May 15, 2019

BOARD OF COUNTY COMMISSIONERS
ORANGE COUNTY, FLORIDA
IFB #Y19-720-CH; ADDENDUM NO. 6

HOLDEN AVENUE – FROM JOHN YOUNG PARKWAY
TO ORANGE BLOSSOM TRAIL (US 441)

SHEET NO.
105

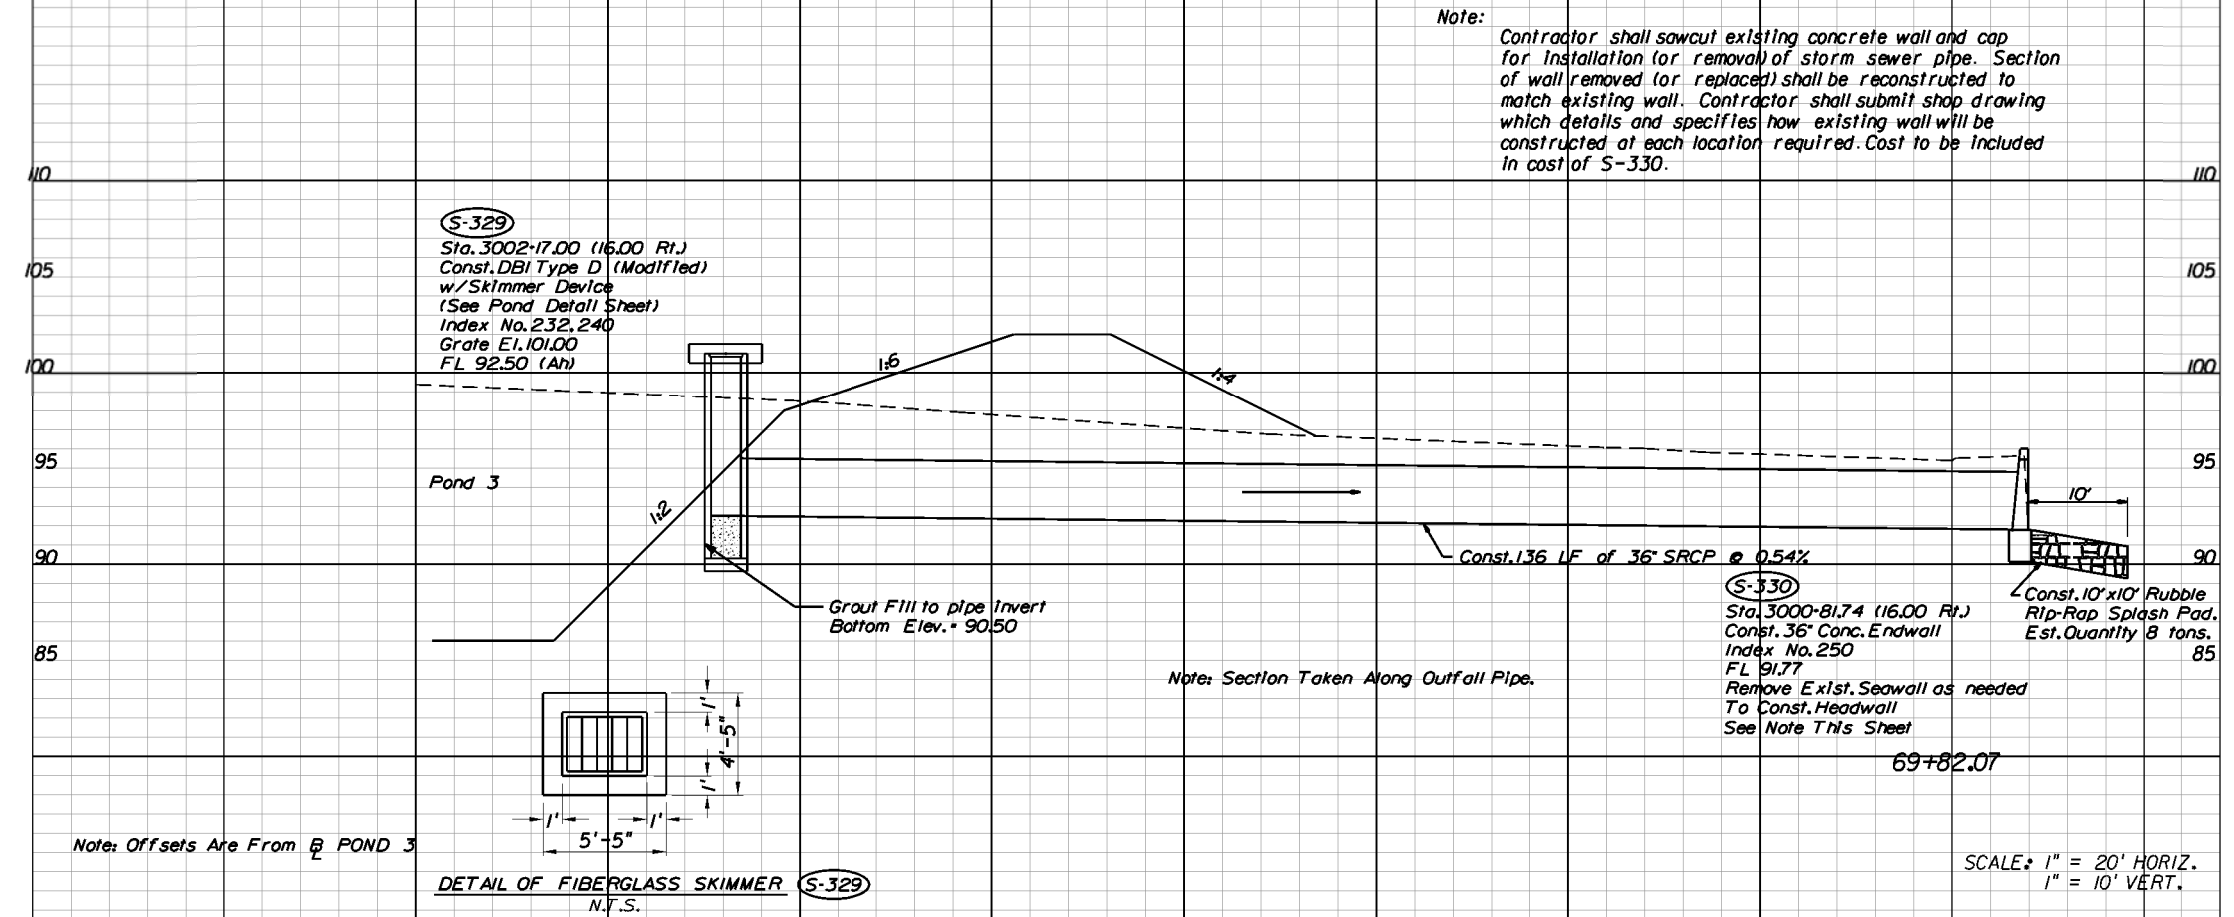
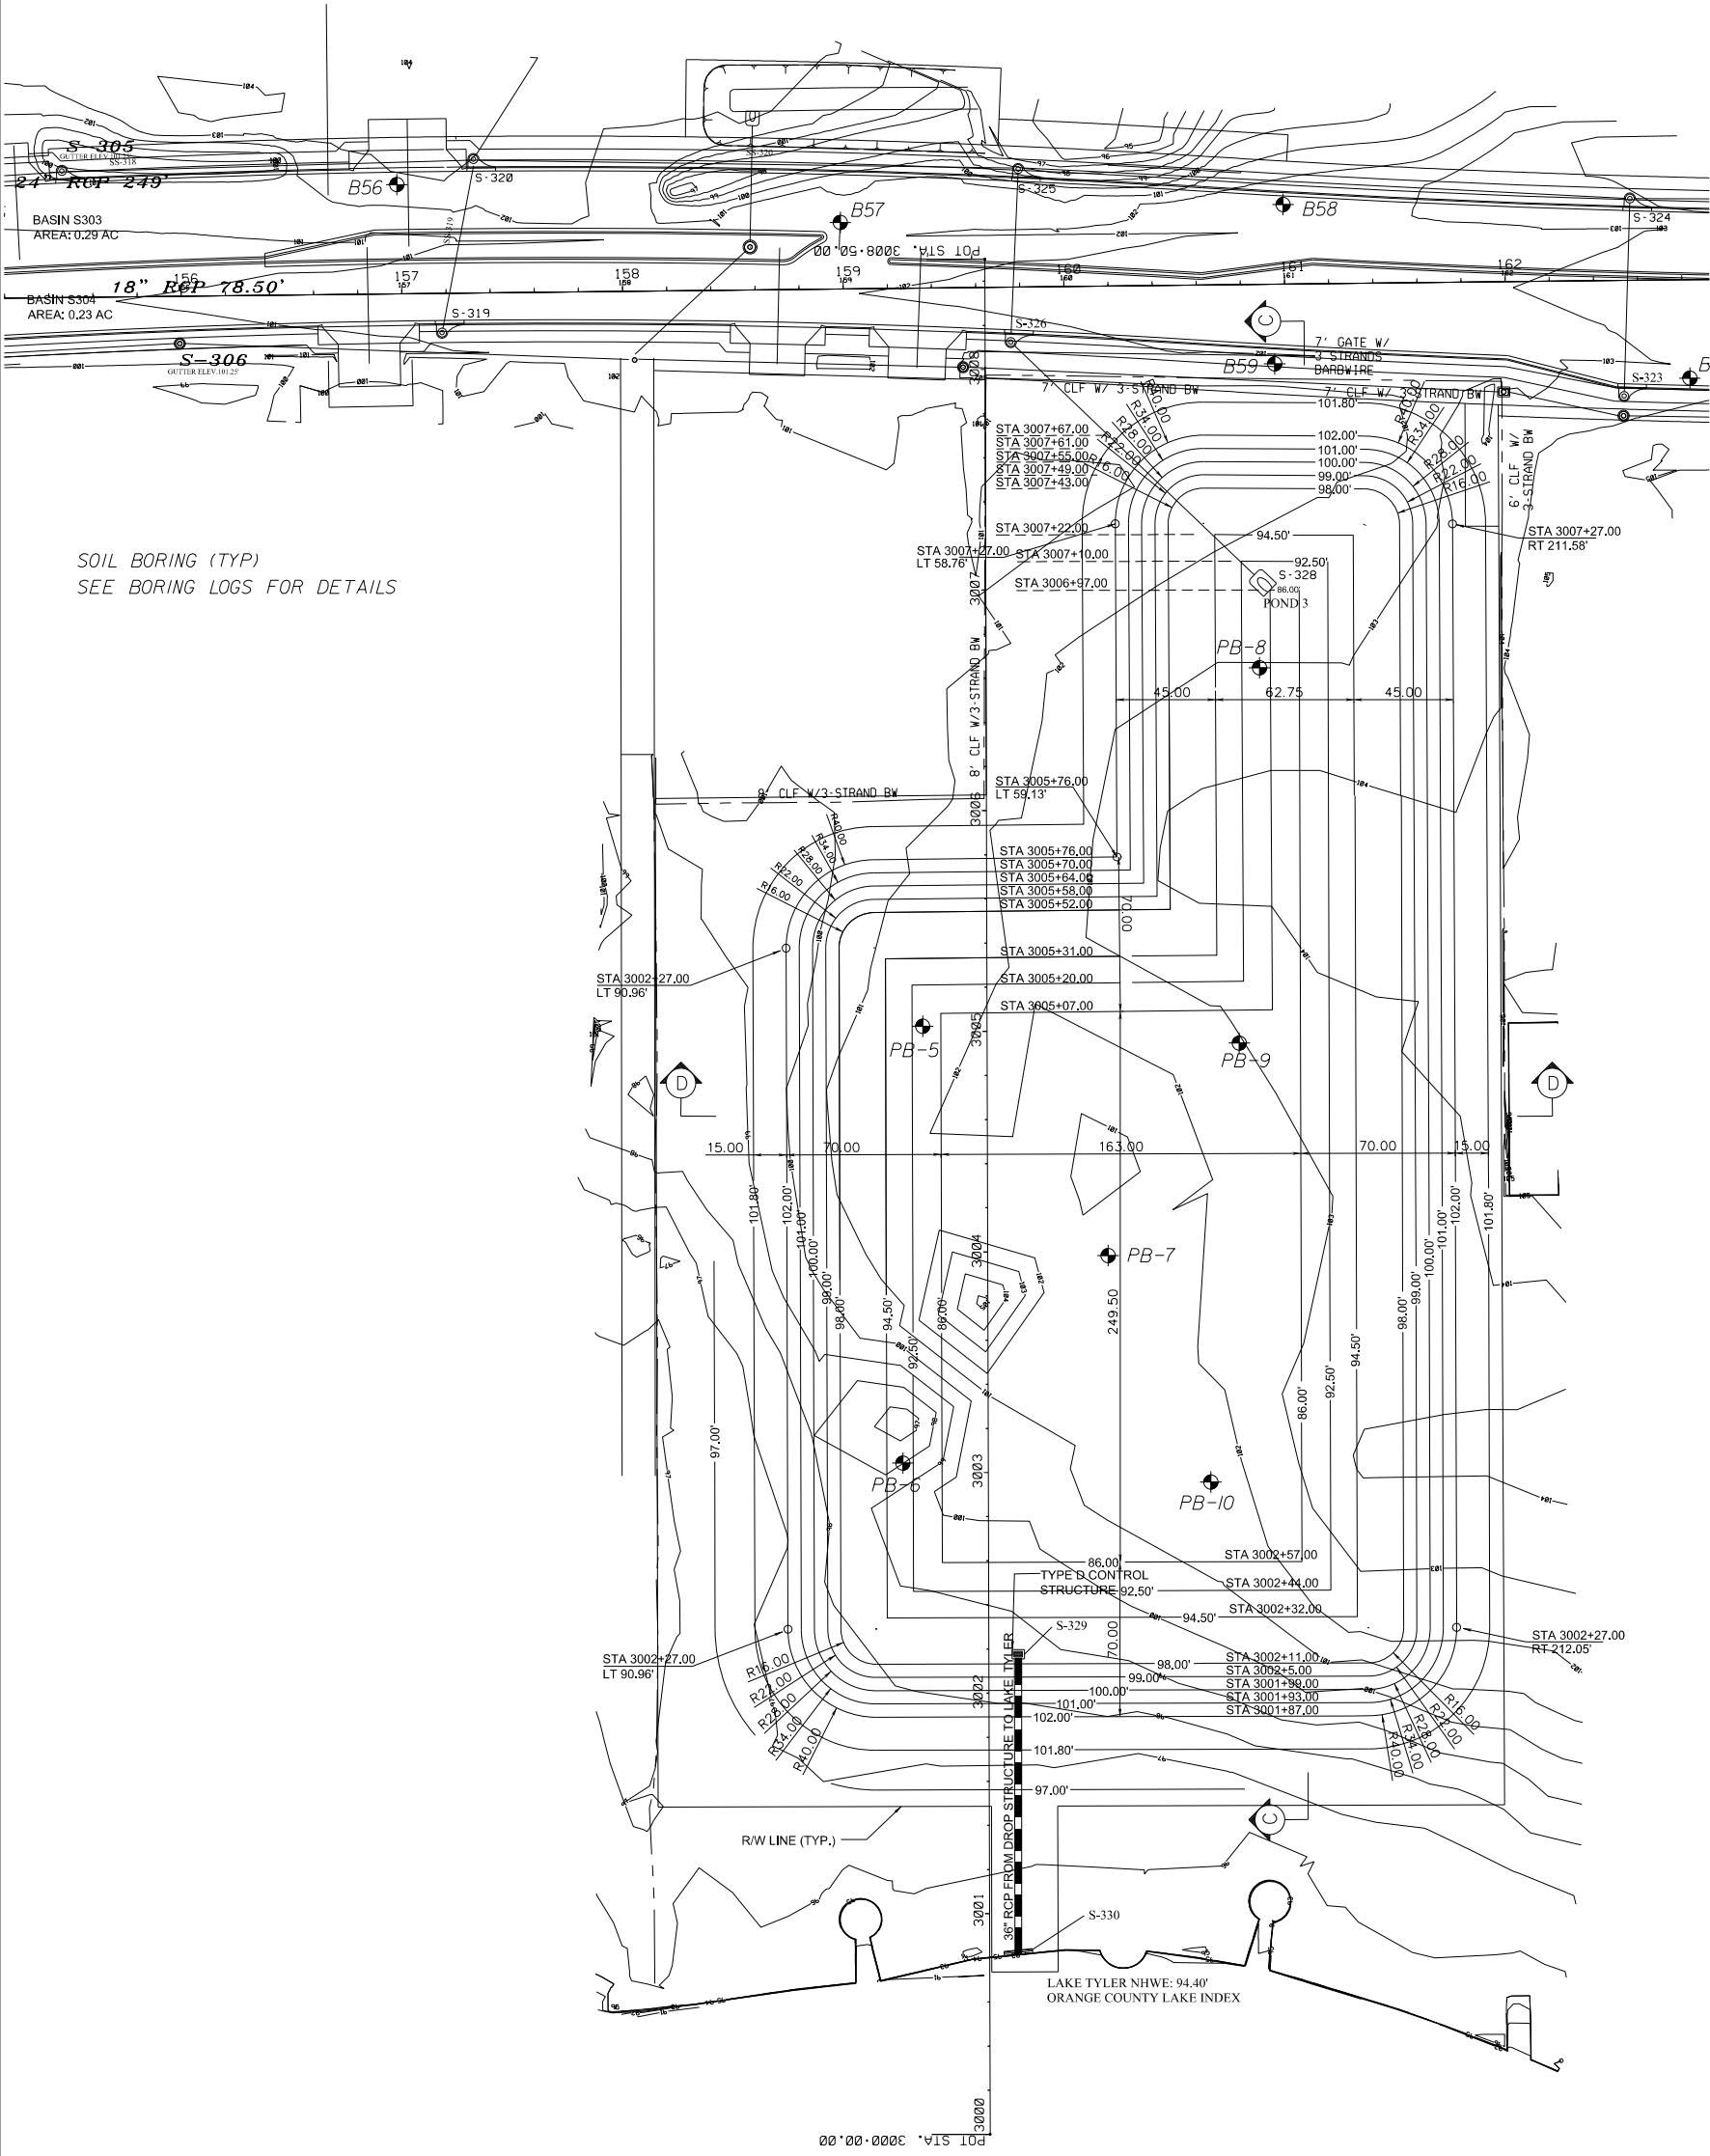
Note: Contractor shall sawcut existing concrete wall and cap for installation (or removal) of storm sewer pipe. Section of wall removed (or replaced) shall be reconstructed to match existing wall. Contractor shall submit shop drawing which details and specifies how existing wall will be constructed at each location required. Cost to be included in cost of S-330.

1. S-330/Pond 3 Outfall: Construction of Structure S-330 (Sta. 3000+81.74 B/L Pond 3, 16' Rt.) will require removal of portions of an existing sea wall with concrete pile cap bordering Lake Tyler. The section of wall to be removed or replaced shall be reconstructed to match the existing wall. The CONTRACTOR shall furnish a signed & sealed shop drawing/design for S-330/**Wall** to the COUNTY for review and approval prior to construction of this structure. Costs for the design, and for the removed/replaced wall, shall be included in the cost of S-330.
